HISTORIC AND DESIGN REVIEW COMMISSION

August 15, 2018

HDRC CASE NO: 2018-394
COMMON NAME: 229 LINDELL PL
LEGAL DESCRIPTION: NCB 6529 BLK 1 LOT 1
ZONING: R-4, H, RIO-1
CITY COUNCIL DIST.: 1
DISTRICT: River Road Historic District
APPLICANT: Joshua Sutton
OWNER: Joshua Sutton
TYPE OF WORK: Amendments to a previously approved design for construction of a single family residential structure
APPLICATION RECEIVED: July 27, 2018
60-DAY REVIEW: September 25, 2018
REQUEST:

The applicant is requesting a Certificate of Appropriateness for approval to amend a previously approved design for new construction. Within this request, the applicant has proposed the following modifications:

PROPOSED ELEVATIONS

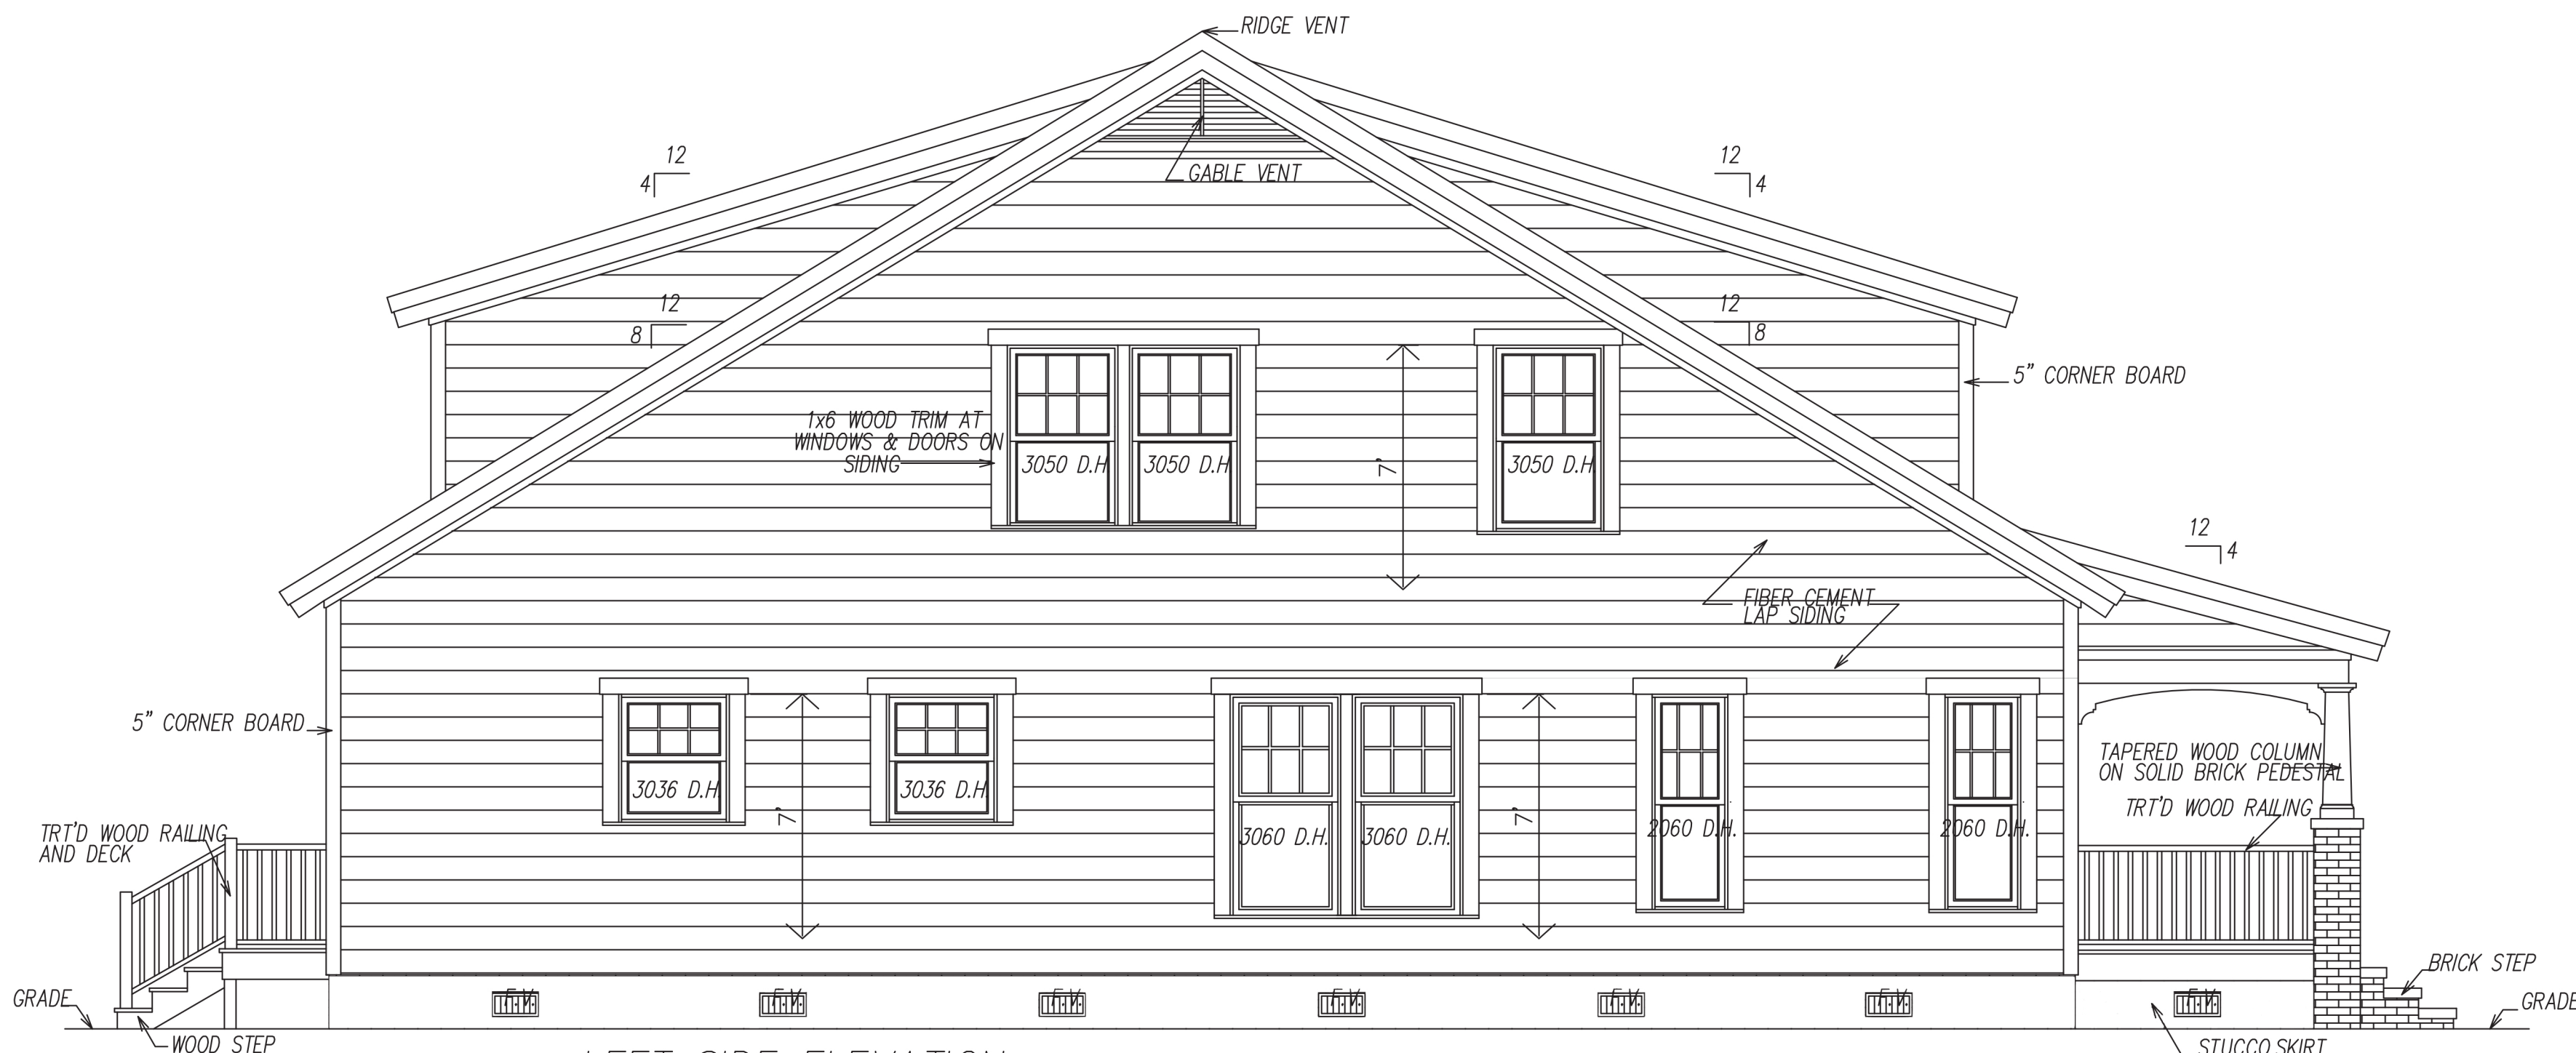
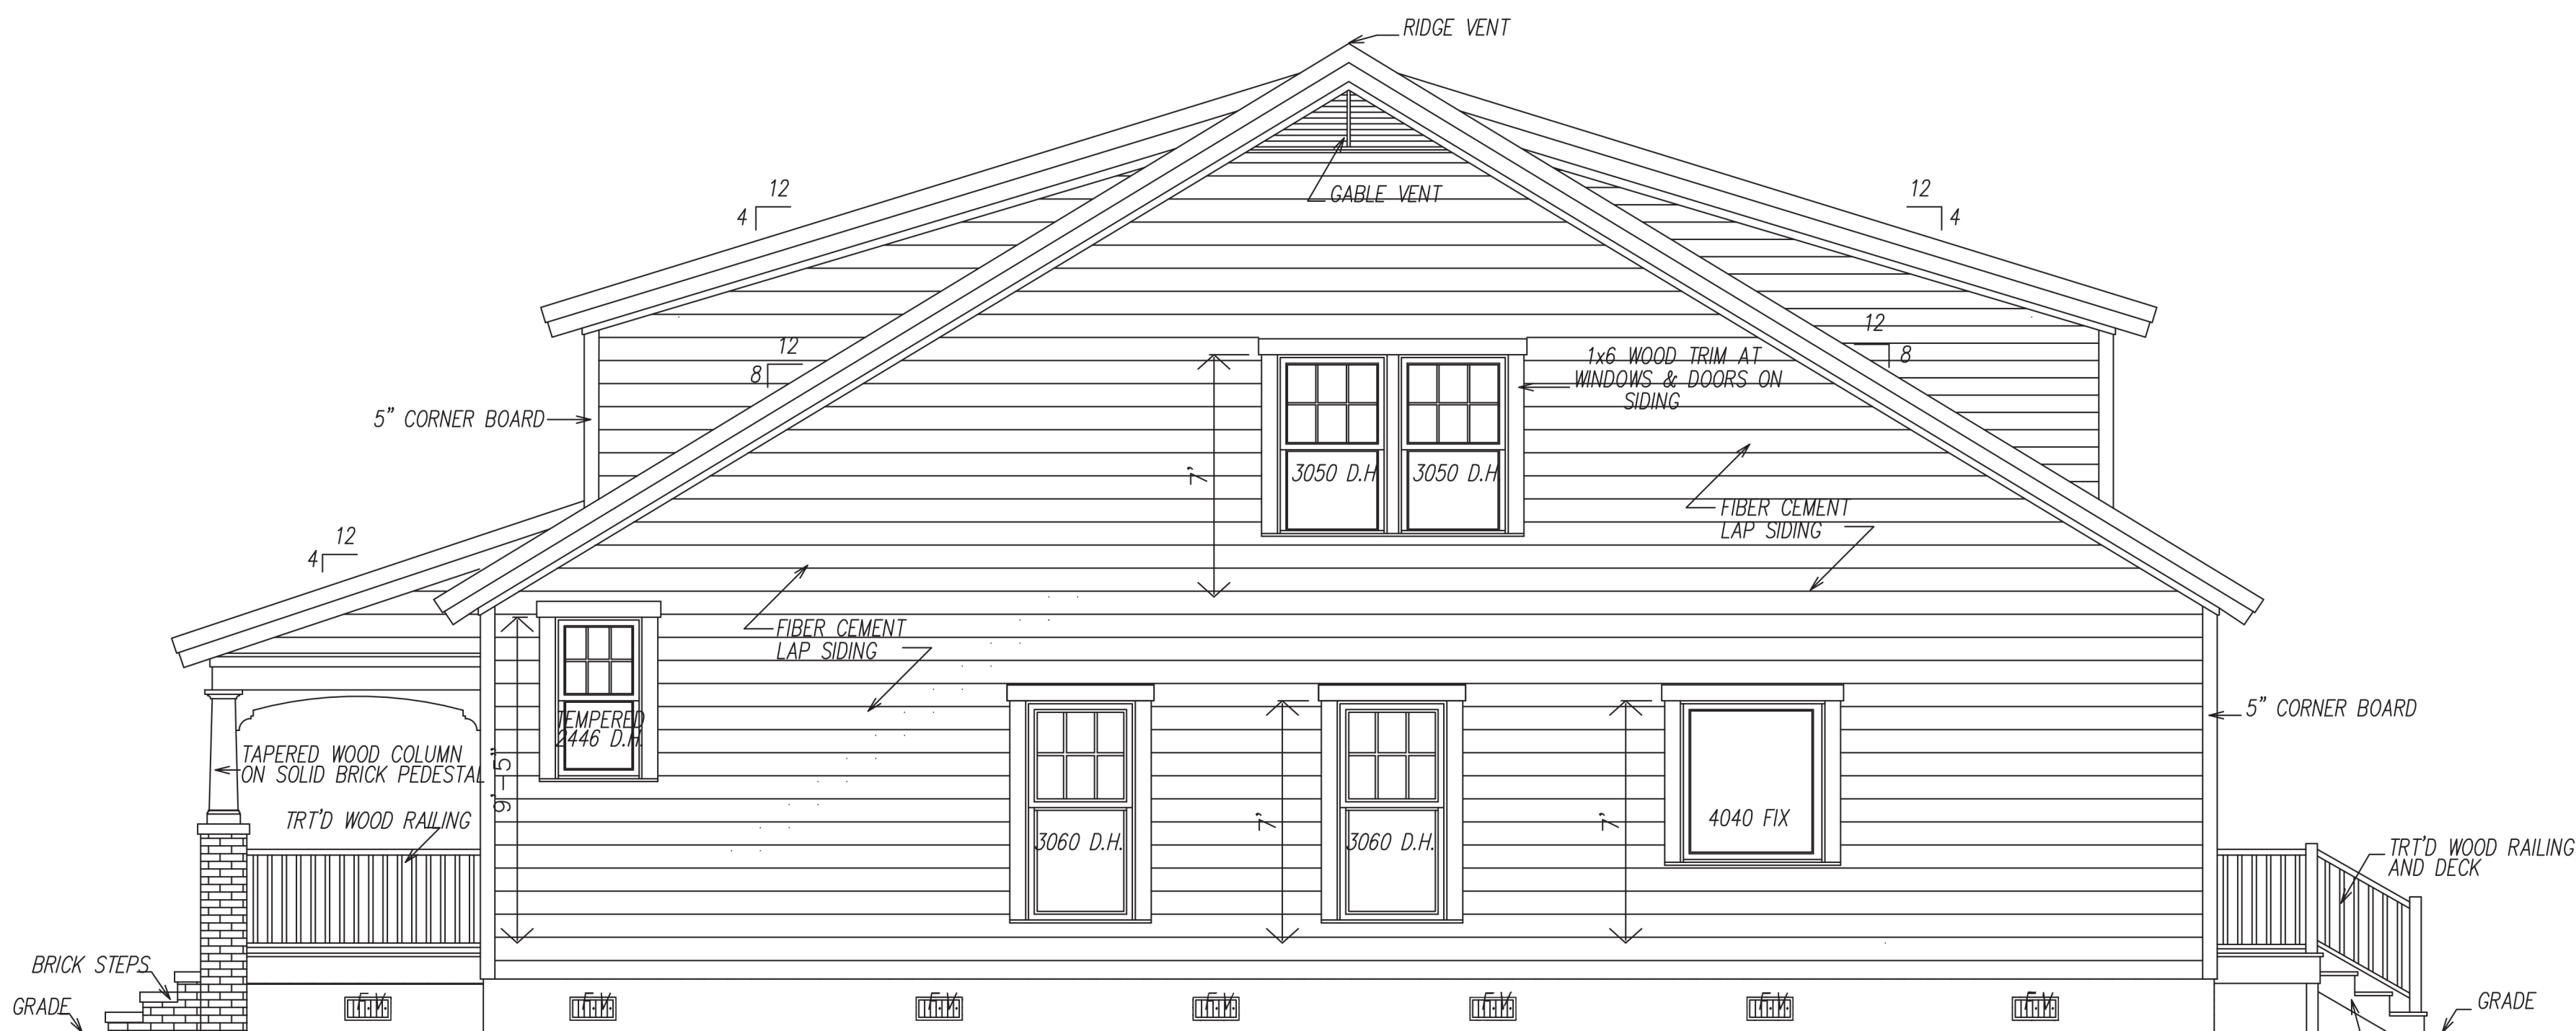
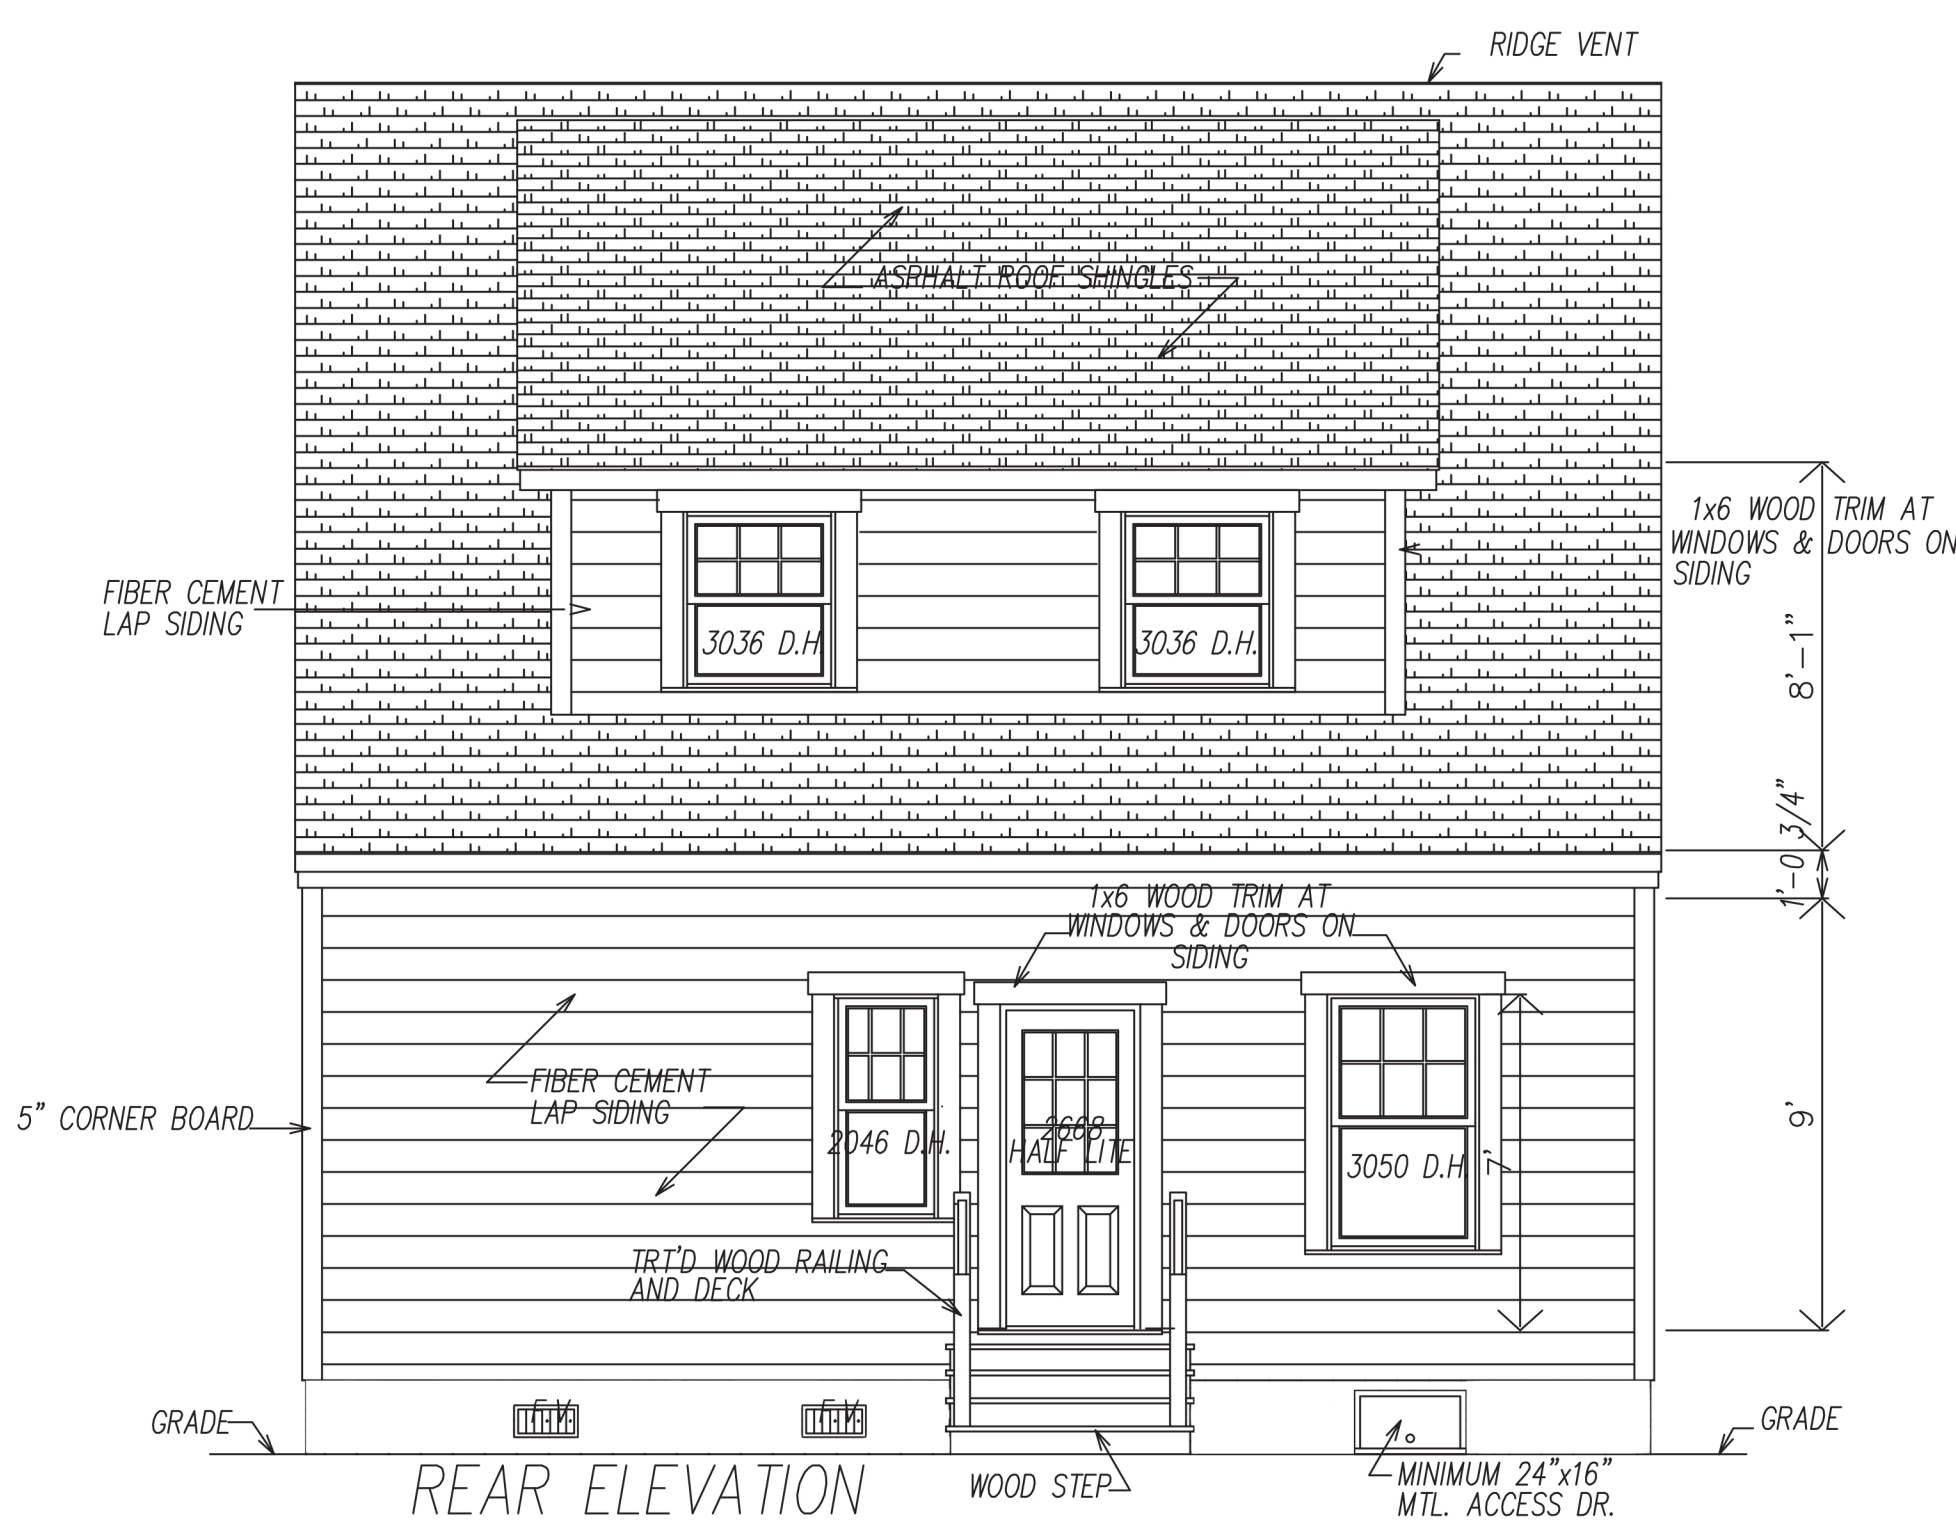
- b. FENESTRATION MODIFICATIONS – The applicant has proposed to modify the previously approved window fenestration to include a centered window with flanking windows on the street facing dormer rather than two sets of double windows. Generally, staff finds the proposed modification to be appropriate. Additionally, the applicant has proposed additional fenestration on both side facades.

- c. WINDOW MATERIALS – The applicant has proposed to install double hung, wood clad aluminum windows rather than the previously approved wood windows. Staff finds this request to be appropriate. The proposed aluminum clad wood windows should feature meeting rails that are no taller than 1.25” and stiles no wider than 2.25”. White manufacturer's color is not allowed, and color selection must be presented to staff. There should be a minimum of two inches in depth between the front face of the window trim and the front face of the top window sash. This must be accomplished by recessing the window sufficiently within the opening or with the installation of additional window trim to add thickness. Window trim must feature traditional dimensions and an architecturally appropriate sill detail. Window track components must be painted to match the window trim or concealed by a wood window screen set within the opening. Grouped windows should be separated by a wood mullion to feature approximately six (6) inches in width. Windows featuring false divided lites are not appropriate.

- d. SIDING – The previous approval include wood siding with an eight (8) inch exposure. The applicant has proposed to install Hardie siding with an eight (8) inch exposure. Staff finds the installation of Hardie siding and trim to be appropriate; however, staff finds that the proposed siding should feature an exposure of four (4) inches.

- i. The proposed aluminum clad wood windows should feature meeting rails that are no taller than 1.25” and stiles no wider than 2.25”. White manufacturer's color is not allowed, and color selection must be presented to staff. There should be a minimum of two inches in depth between the front face of the window trim and the front face of the top window sash. This must be accomplished by recessing the window sufficiently within the opening or with the installation of additional window trim to add thickness. Window trim must feature traditional dimensions and an architecturally appropriate sill detail. Window track components must be painted to match the window trim or concealed by a wood window screen set within the opening. Grouped windows should be separated by a wood mullion to feature approximately six (6) inches in width. Windows featuring false divided lites are not appropriate.

- ii. That the proposed Hardie siding feature an exposure of four (4) inches.
- iii. That the proposed accessory structure feature two garage doors that are wood or aluminum in material.
